ADDENDUM #1

Project Name: GRC Kitchen Tunnel Repair
DAS #9018.00
RFB #0919335025
Dated: October 25, 2018

A. M0.0 – Mechanical Coversheet

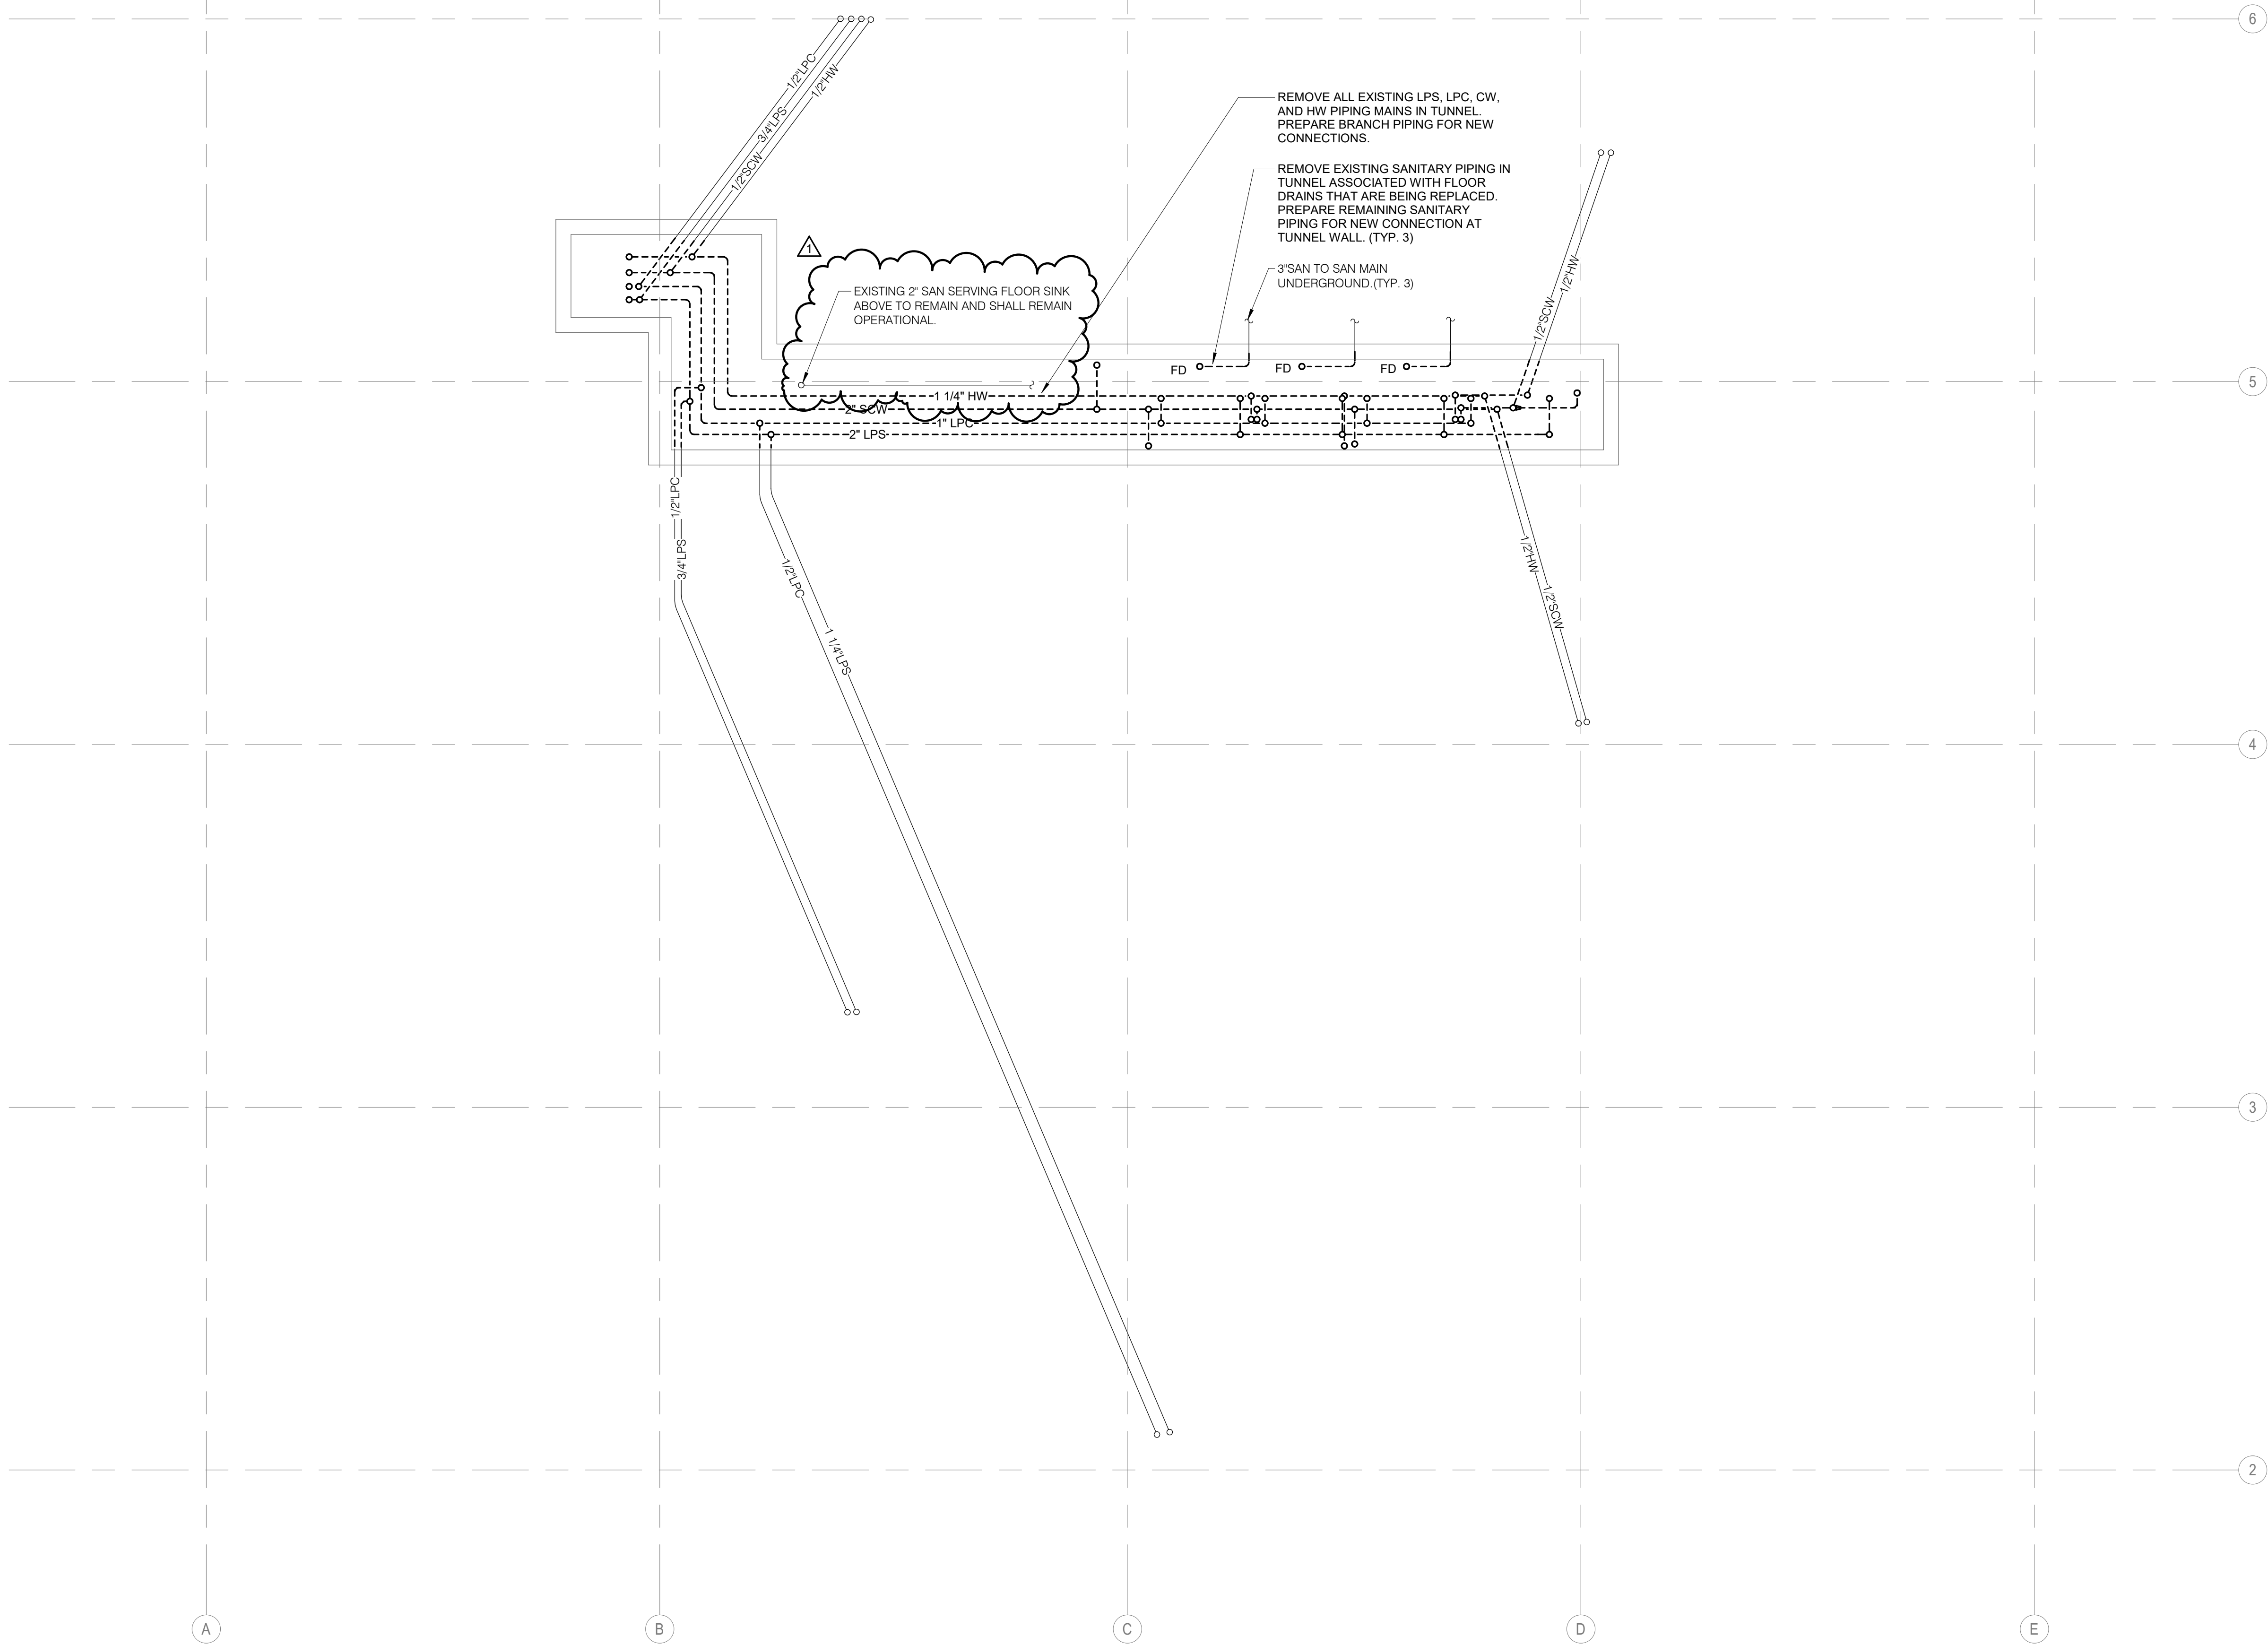
1. **REVISE** the FD-1 listed in the Plumbing Material List to be FS-1. Refer to revised sheet M0.0 attached.

B. MD1.0 – Tunnel Floor Plan – Mechanical – Demolition

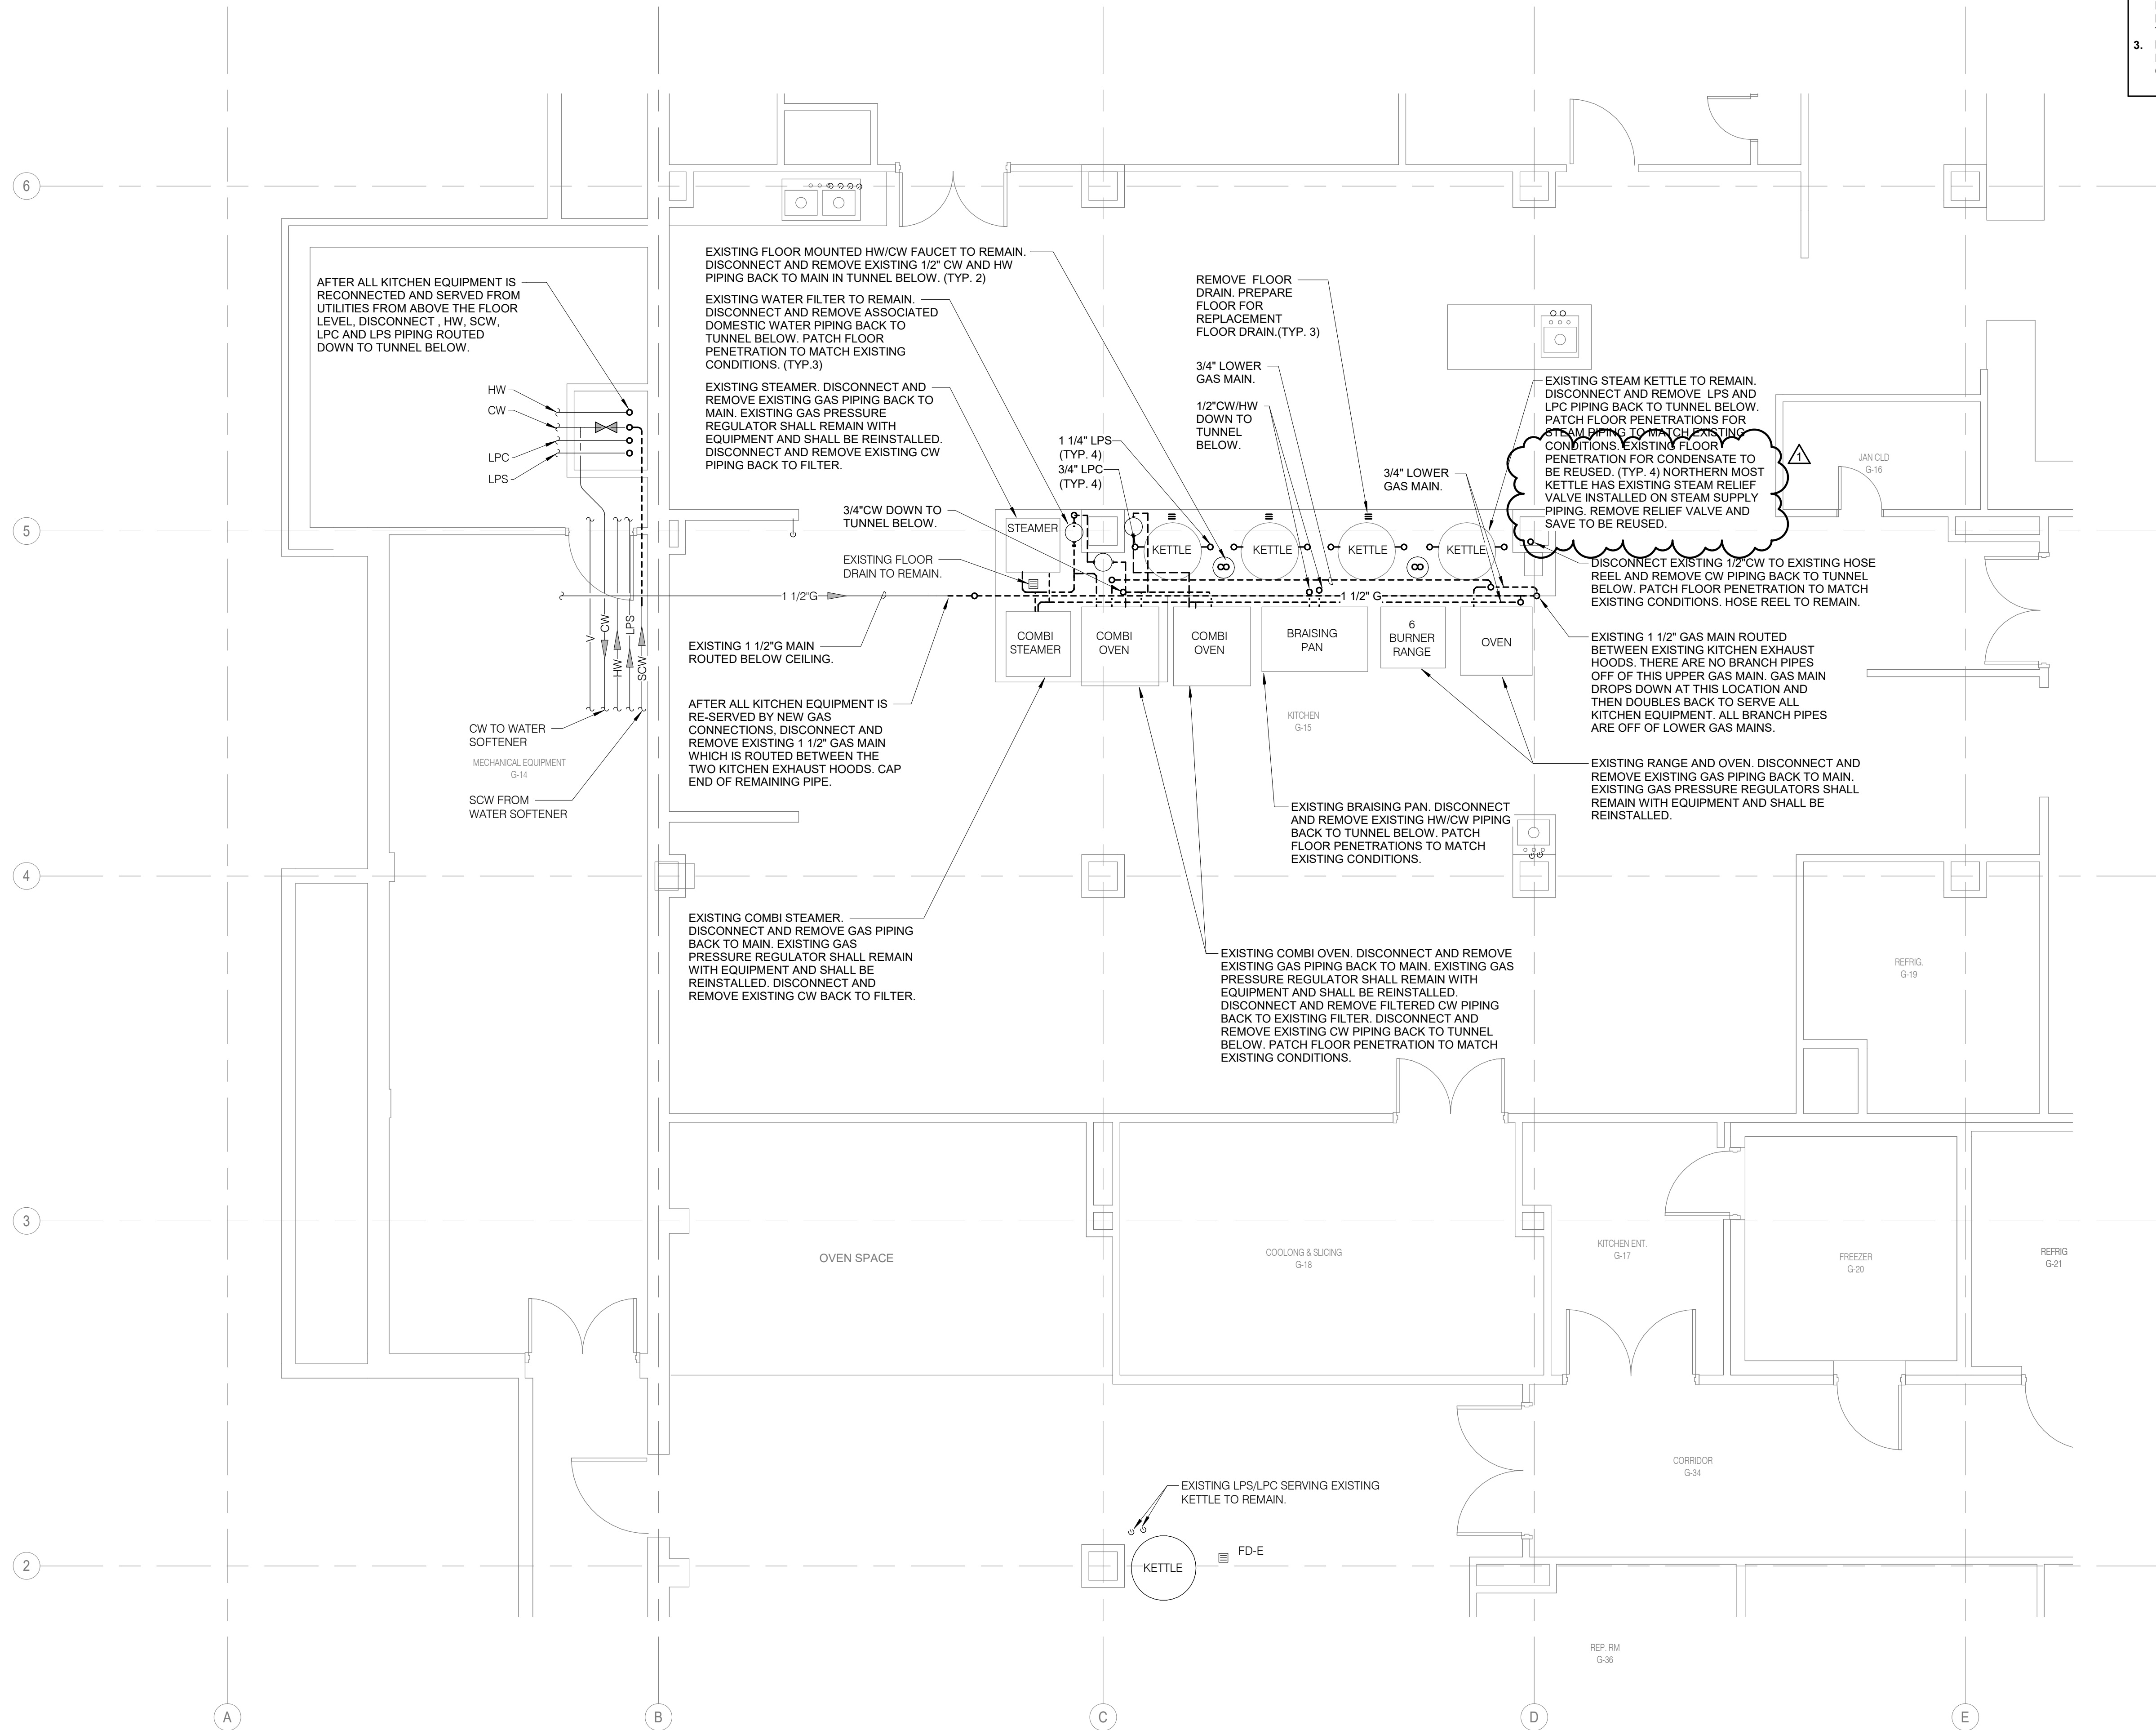
1. **ADD** a 2" sanitary drain line in the tunnel that is to remain. Refer to revised sheet MD1.0 attached.

C. MD1.1 – First Floor Plan – Mechanical – Demolition

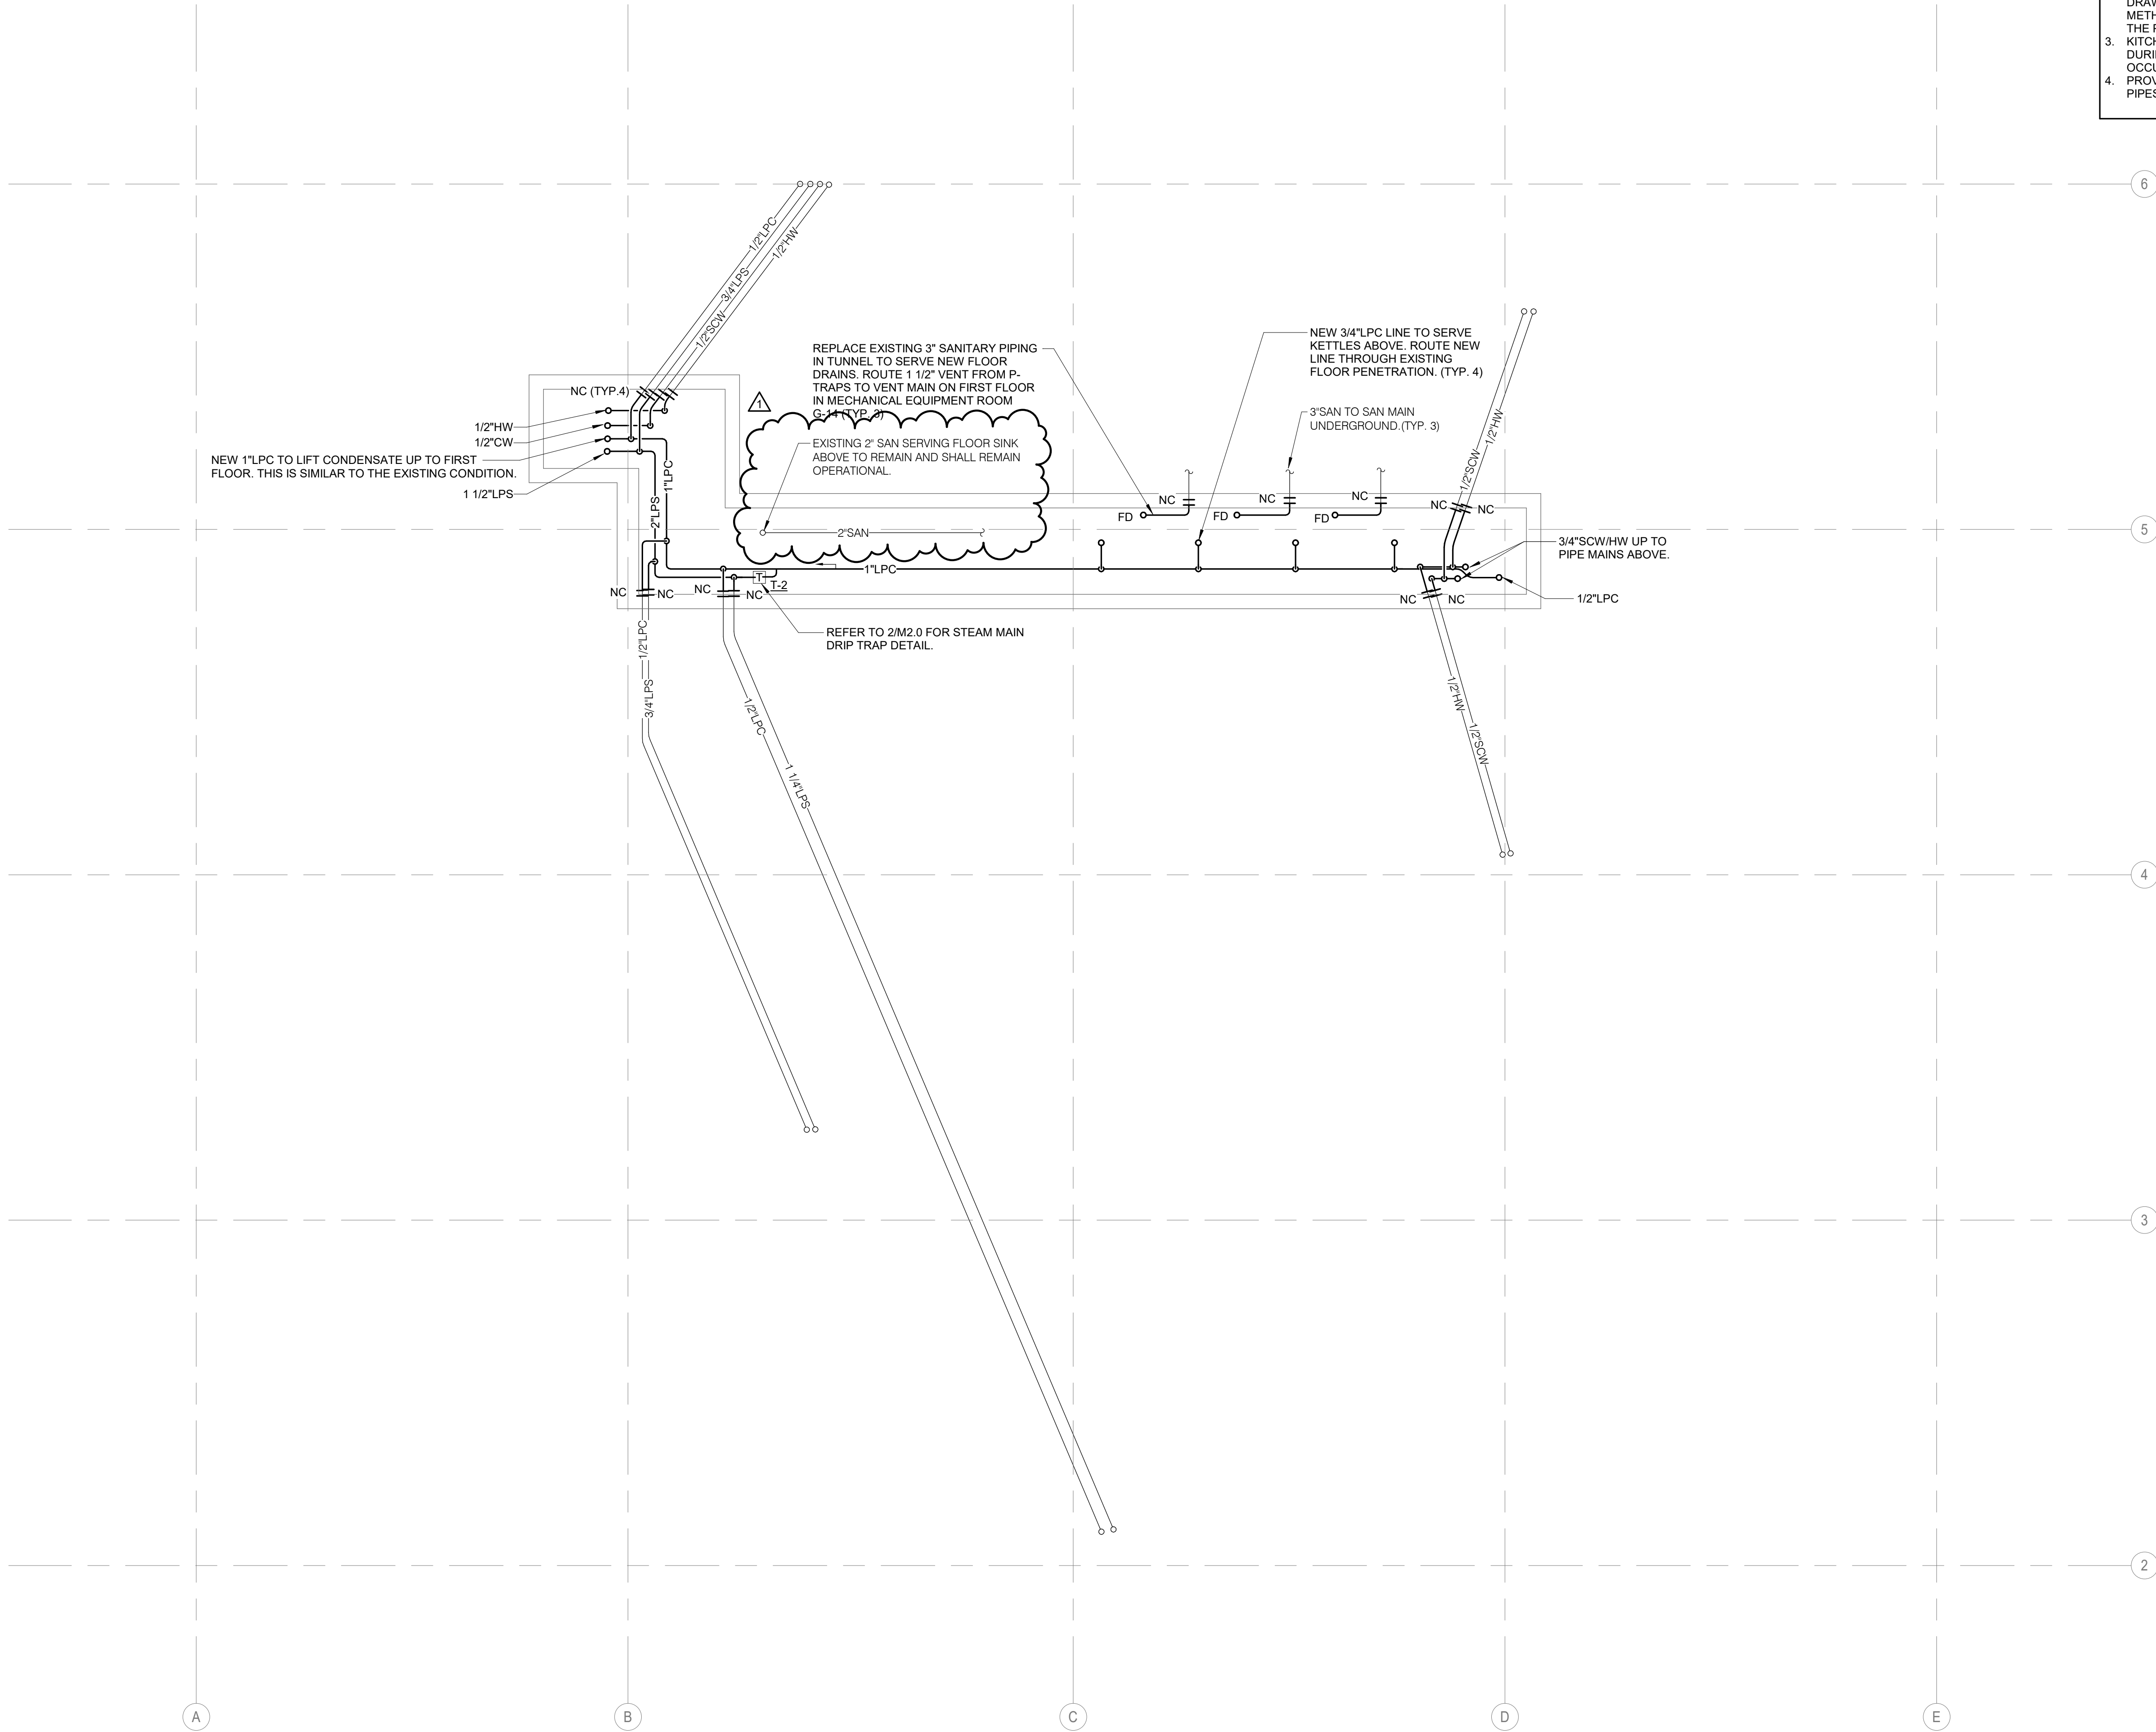
1. **ADD** note to remove the existing steam relief valve on one of the steam kettles and save valve to be reused. Refer to revised sheet MD1.1 attached.
